UNITED STATES PATENT AND TRADEMARK OFFICE

10/797,255

Office Action Summary

DETAILED ACTION

Gray French; Figure 1, page 67

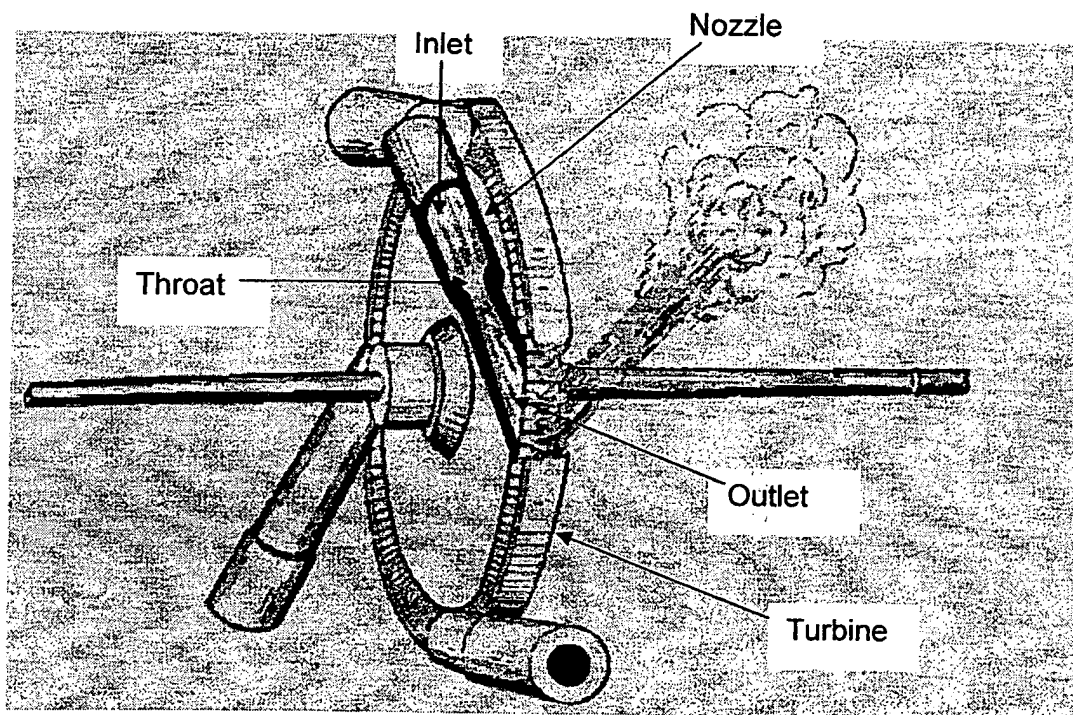
18. Regarding Claim 4, Gray French teaches a system comprising a nozzle having an inlet, a throat, and an exhaust (see figure below); a fluid flowing through the nozzle; and a means (i.e. turbine) for transforming the flow from the exhaust into work outside the system. Gray French fails to teach a means embedded within the nozzle for transferring energy into and heating the nozzle, thereby indirectly transferring energy into and heating the fluid and inducing a phase change in the fluid. Patterson teaches a means 38/44/36 embedded within a nozzle 12 for transferring energy into and heating the nozzle 12 (column 2, lines 15-17); thereby indirectly (through means 36) transferring energy into and heating the fluid and inducing a phase change in the fluid (column 3, lines 59-60).

19. Regarding Claim 5, Gray French teaches a system wherein the cross-sectional interior volume of the inlet, throat, and exhaust of the nozzle vary only across one plane perpendicular to the axis of the fluid flowing through the nozzle (see figure below).
